Subject: NSD Drawing Request (need date pending) - MSP Mill City Tavern
From: Barb Alger <balger@squierinc.com>
Date: 2/16/2022, 2:53 PM
To: David Bethel <ddb@davidbethel.com>
CC: Roxanne Holt <Roxanne.Holt@vulcanhart.com>

Subject: Revision Request (COB 4/8/22 or sooner): MSP MILL CITY TAVERN - VH-MSPMC (Next Step Design)
From: Barb Alger <balger@squierinc.com>
Date: 4/6/2022, 11:46 AM
To: David Bethel <ddb@davidbethel.com>
CC: Chris Cook <chris.cook@itwce.com>

VH-MSPMC : MSP MILL CITY TAVERN

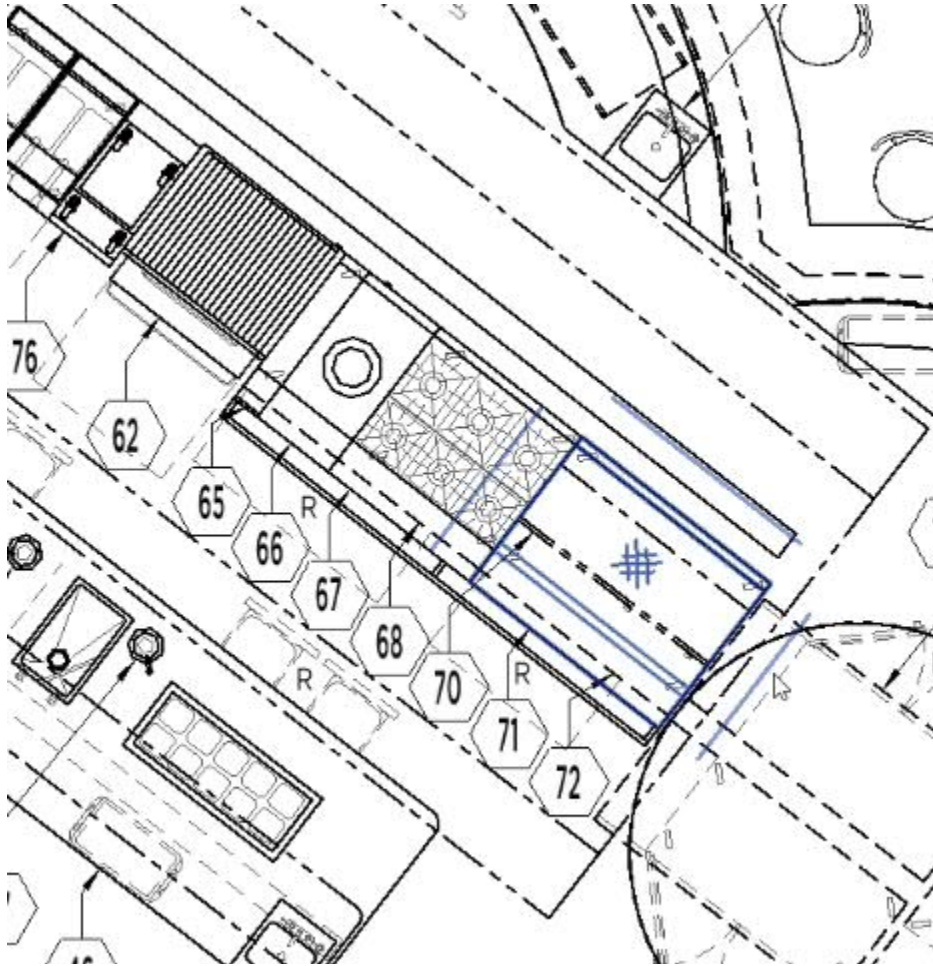
- For the items listed below we are wondering if we would be able to have this open riser with a refrigerated base? If possible could you provide us with the information we will need to spec for this range mounted option. If this mounting option is not an option do you have any other suggestions we could explore? This is going to be an open kitchen the client does not want to have the closes riser.
 - Item #70 – Cheesemelter, model #VICM48
 - Item #71 – Griddle, model #VGM36
 - Item #72 – Refrigerated Base, Continental, model #D48GN

Please note to ignore Item #65 in the snip below, please refer to PDF's provided.
